SUBJECT: Forwards response to NRC 791212 questions & 800111 telcon re degraded grid voltage.

Re: Oconee Nuclear Station
Docket Nos. 50-269, -270, -287

OCONEE NUCLEAR STATION

NRC Request for Information
Degraded Grid Voltage

Figure 1

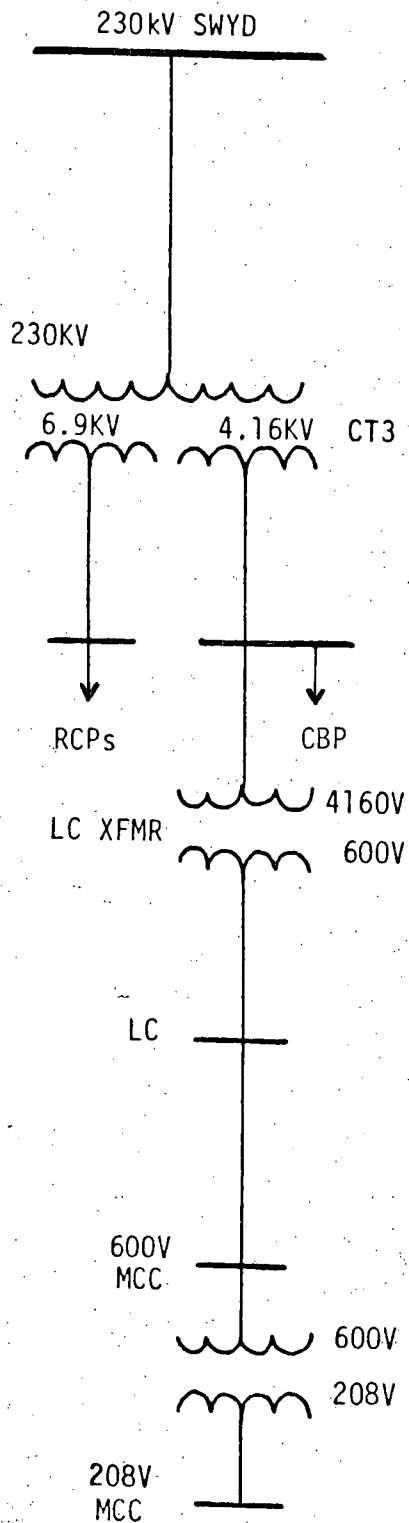
8. In the January 11, 1980 telecon between Duke and NRC, the NRC asked that Duke respond to Item 3 of their Guidelines for Voltage Drop Calculations.
3. All actions the electric power system is designed to automatically initiate should be assumed to occur as designed (e.g., automatic bulk or sequential loading or automatic transfers of bulk loads from one transformer to another). Included should be consideration of starting of large non-safety loads (e.g., condensate pumps).

Position 3 of the NRC Guidelines for Voltage Drop Calculations states that the voltage analysis should consider the starting of a large non safety-related motor at a time following the transfer of all normally running loads to the startup transformer and the starting of all required ES loads (i.e., after steady-state conditions have been established on the power distribution system).

An analysis has been performed considering the starting and running of a 2000 HP Condensate Booster Pump under the conditions described above. The analysis shows that the non safety-related pump will start and that its starting has no adverse effects on the already running loads. Figures 1 and 2 provide the voltage profiles for starting and running the Condensate Booster Pump in addition to the previously analyzed loads.
